UNITED STATES PATENT AND TRADEMARK OFFICE

APPLICATION NO.	FILING DATE	FIRST NAMED INVENTOR	ATTORNEY DOCKET NO.	CONFIRMATION NO.
09/398,652	09/17/1999	WILLIAM A. SAMARAS	042390.P5120D	1359

# Office Action Summary

**DETAILED ACTION**

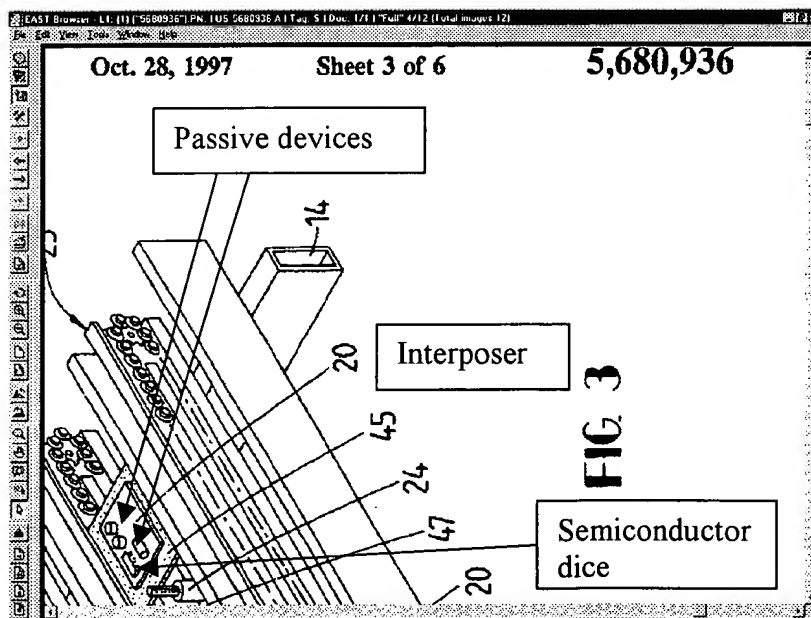
Beers discloses soldering at least one passive device (see annotated Fig. 3 below and col. 1, lines 28-32) thereby regulating voltage and current to the electronic dice.
